SCOPE AND PROPOSED FINISH	
1	QUOTATION / DFM REVIEW ONLY - NOT RELEASED FOR MACHINING.
2	Units mm. Do not scale. Read with sheet 2 and frame-reference.step.
3	One-piece lower frame; caps, keys, pads and hardware excluded.
4	CNC mill/drill from solid. Sheet profile cutting alone is insufficient.
5	Material: titanium; grade and stock condition to be agreed.
6	Nominal geometry retained from PETG prototype d24a674.
7	Proposed general linear tolerance +/-0.10; angles +/-0.5 deg.
8	Functional fits on sheet 2 override general proposal; confirm before release.
9	Deburr all edges. Proposed edge break 0.10-0.20 except fits/stops.
10	Whistle seats: proposed Ra 1.6 um; no burrs or tool ridges.
11	Protect spring seats, stop faces and bearing lands from edge breaks.
12	CAD defines unlisted contours; all sharp internal corners need DFM review.
13	Section A-A: foot-end clamp at Y=0. Pocket floor Z=1.90.
14	Base top Z=3.50; nominal nut-pocket roof thickness 1.60.

TITLE	FRAME / MACHINING REVIEW	DWG NO.	WK-TI-001-1	SCALE	2:1	MAT.	Ti / TBD	REV	P1
GEN. TOL.	DRAFT / SEE NOTES	DRAWN BY	PZFREO / draftwright

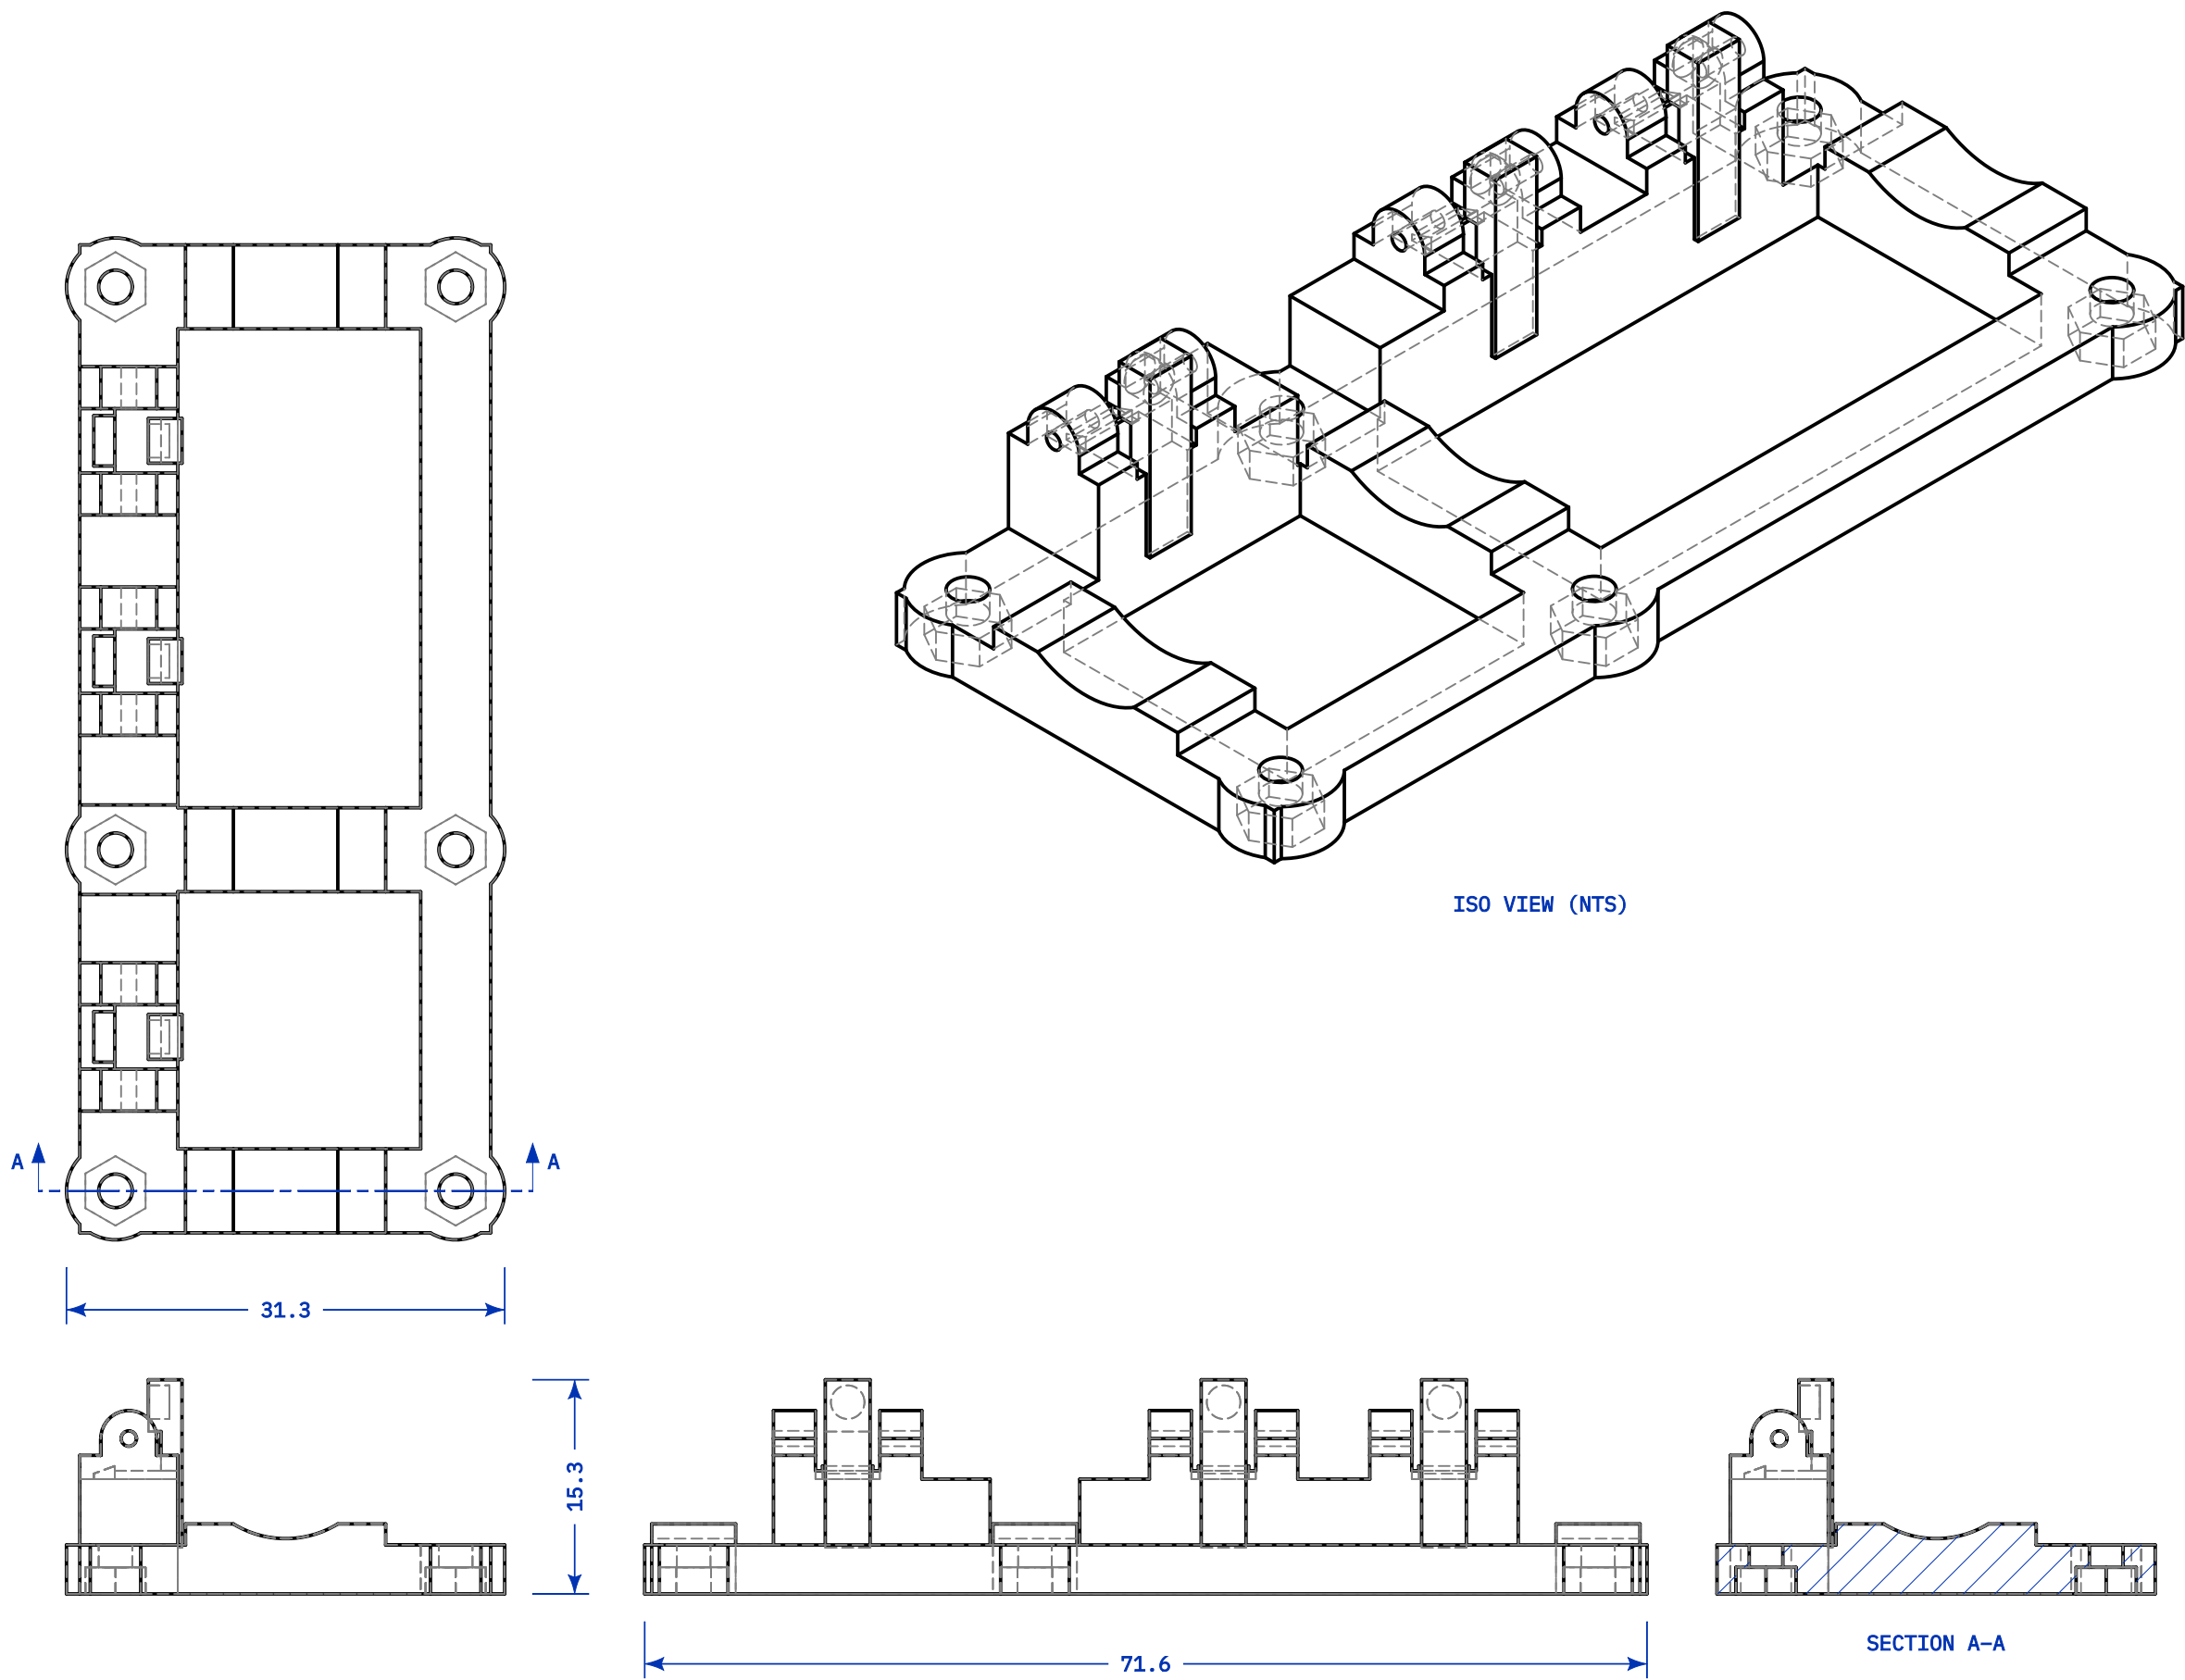
RELEASE HOLDS	
1	HOLD 1: confirm hole 5/6 measurements and resulting key positions.
2	HOLD 2: 1.10 CAD pin bores are a PRINT allowance, not a metal friction fit.
3	Agree pin retention and bore limits using actual 1 x 12 steel pins.
4	HOLD 3: six sharp hex pockets need EDM/broaching or approved relief.
5	No unapproved cutter radii in key sweeps, seats or nut corners.
6	HOLD 4: confirm titanium grade, clamp fit and all proposed tolerances.
7	A geometry drawing does not establish titanium clamp compliance.
